REDLINE 6/1/2007 TEDD APPROVAL *JDD 6/1/07*

SHA STATE OF MARYLAND
DEPARTMENT OF TRANSPORTATION
STATE HIGHWAY ADMINISTRATION
OFFICE OF TRAFFIC & SAFETY
TRAFFIC ENGINEERING DESIGN DIVISION
TRAFFIC SIGNAL PLAN

MD 213 INTERCHANGE AND US 301 NORTH RAMP, US 301 SOUTHBOUND RAMP

SIGNALIZATION PLAN SHEET

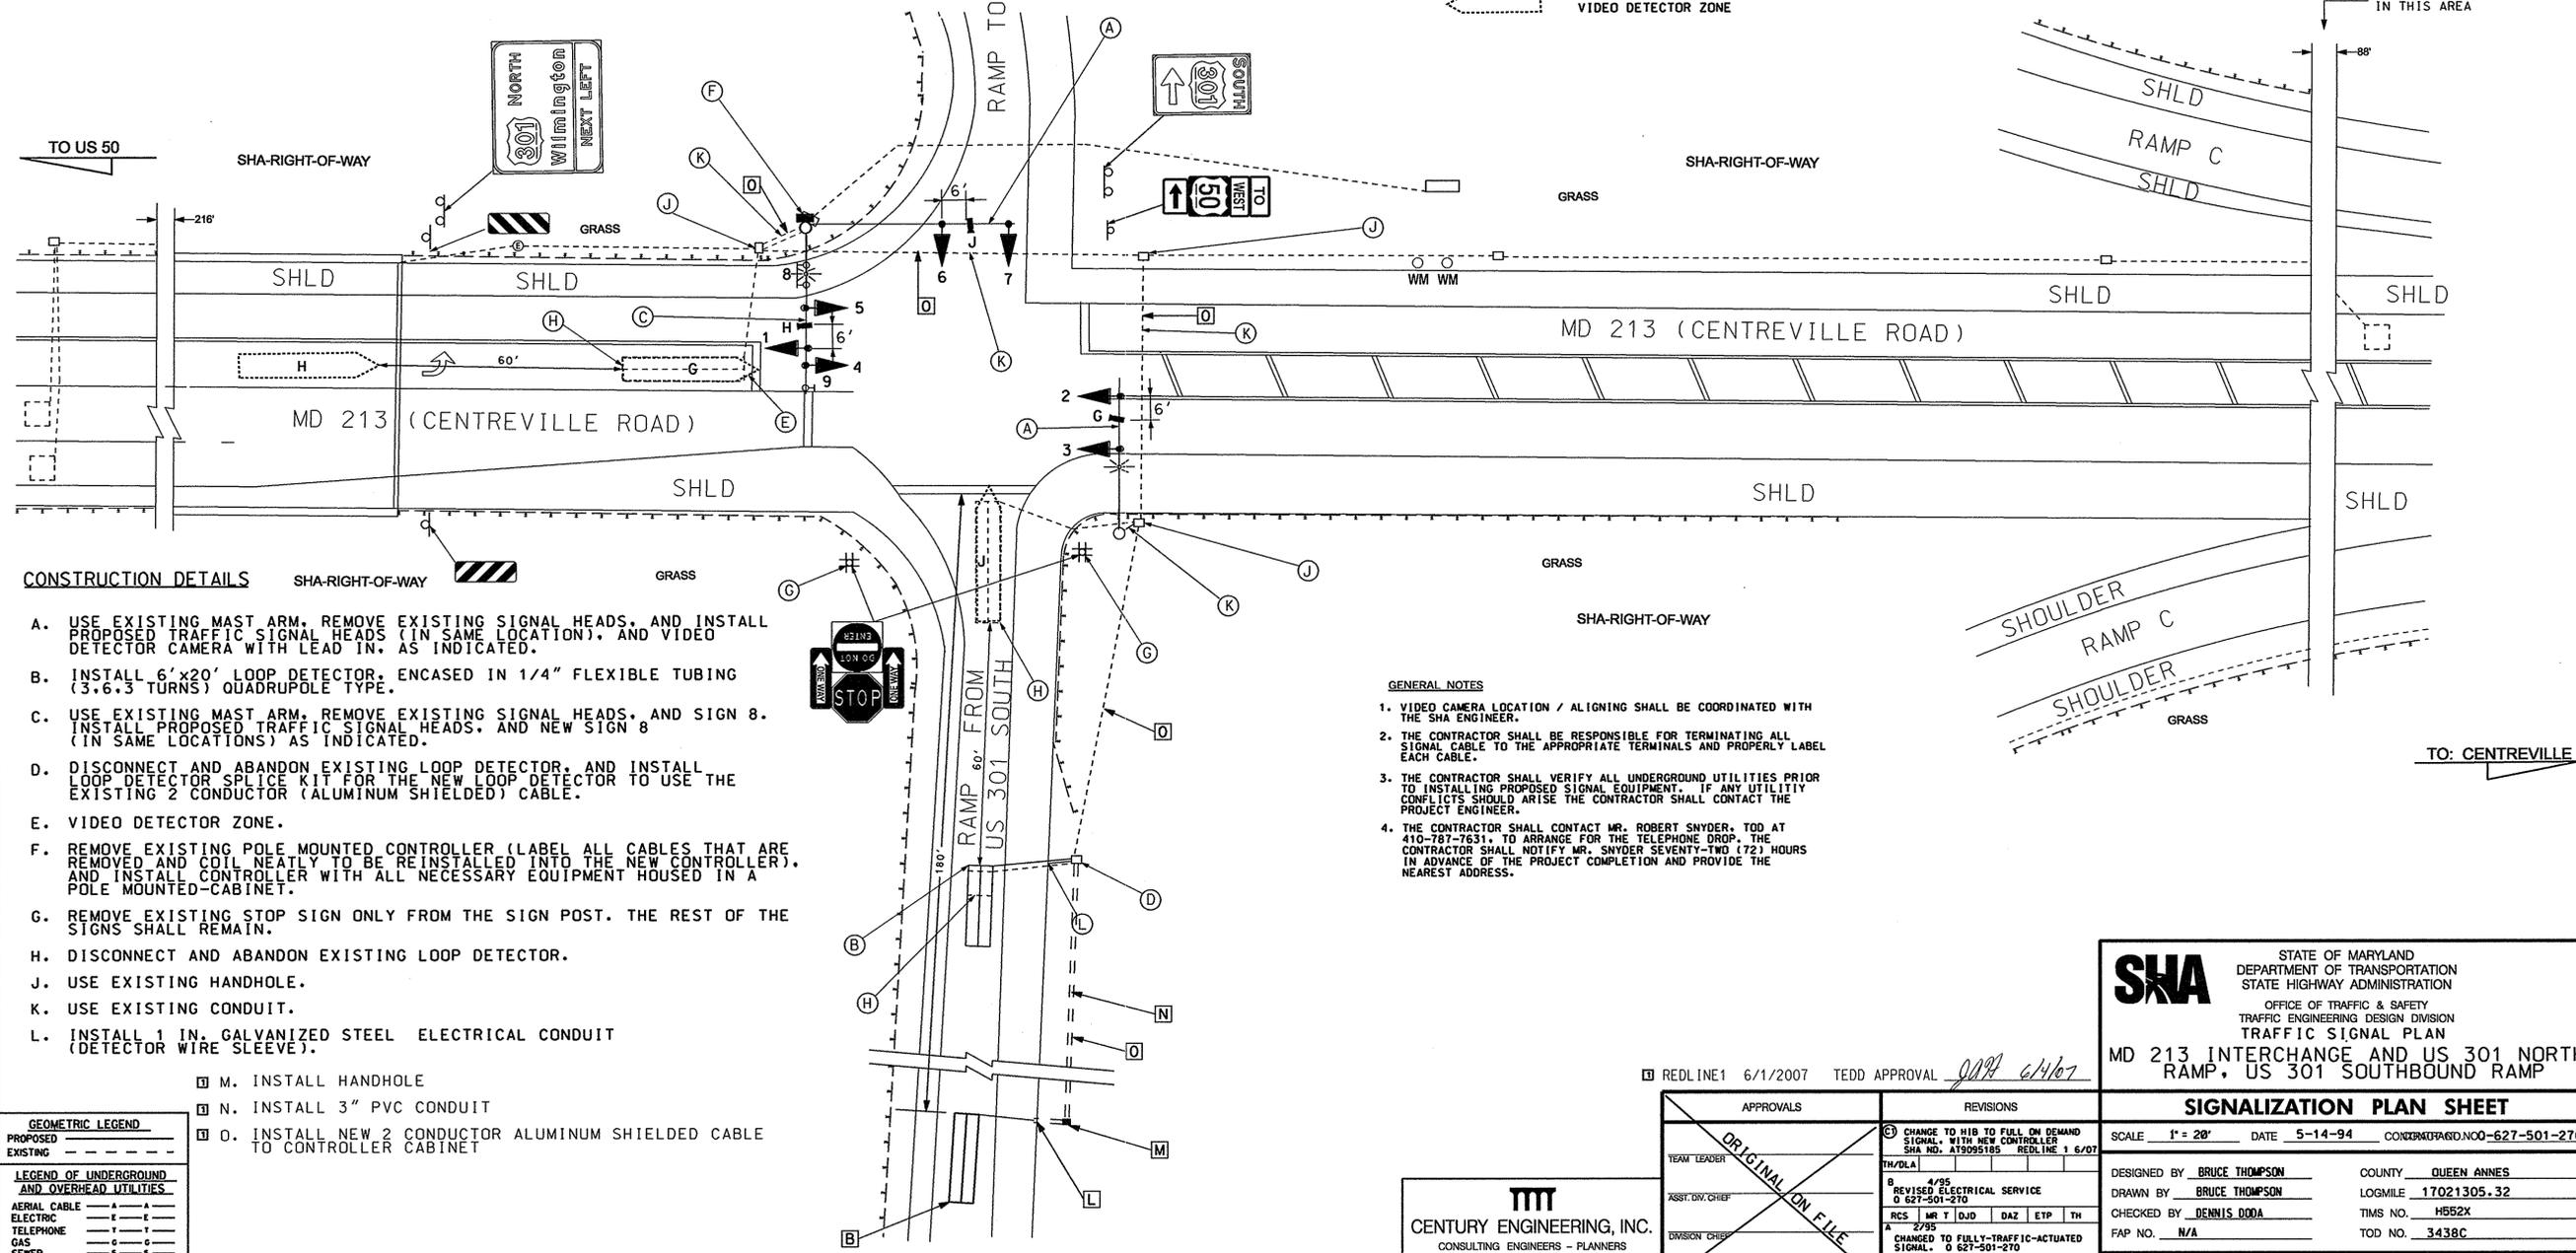
- A. USE EXISTING MAST ARM, REMOVE EXISTING SIGNAL HEADS, AND INSTALL PROPOSED TRAFFIC SIGNAL HEADS (IN SAME LOCATION), AND VIDEO DETECTOR CAMERA WITH LEAD IN, AS INDICATED.

- B. INSTALL 6'x20' LOOP DETECTOR, ENCASED IN 1/4" FLEXIBLE TUBING (3.6.3 TURNS) QUADRUPOLE TYPE.
- C. USE EXISTING MAST ARM, REMOVE EXISTING SIGNAL HEADS, AND SIGN 8. (IN SAME LOCATIONS) AS INDICATED.

- D. DISCONNECT AND ABANDON EXISTING LOOP DETECTOR, AND INSTALL LOOP DETECTOR SPLICE KIT FOR THE NEW LOOP DETECTOR TO USE THE EXISTING 2 CONDUCTOR (ALUMINUM SHIELDED) CABLE.

- E. VIDEO DETECTOR ZONE.
- F. REMOVE EXISTING POLE MOUNTED CONTROLLER (LABEL ALL CABLES THAT ARE REMOVED AND COIL NEATLY TO BE REINSTALLED INTO THE NEW CONTROLLER), AND INSTALL CONTROLLER WITH ALL NECESSARY EQUIPMENT HOUSED IN A POLE MOUNTED-CABINET.

REVISIONS	
1	CHANGE TO HIB TO FULL ON DEMAND SIGNAL, WITH NEW CONTROLLER SHA NO. A19095105 REDLINE 1 6/07
2	4/95 REVISED ELECTRICAL SERVICE 0 627-501-270
3	2/95 CHANGED TO FULLY-TRAFFIC-ACTUATED SIGNAL. 0 627-501-270
PRZ
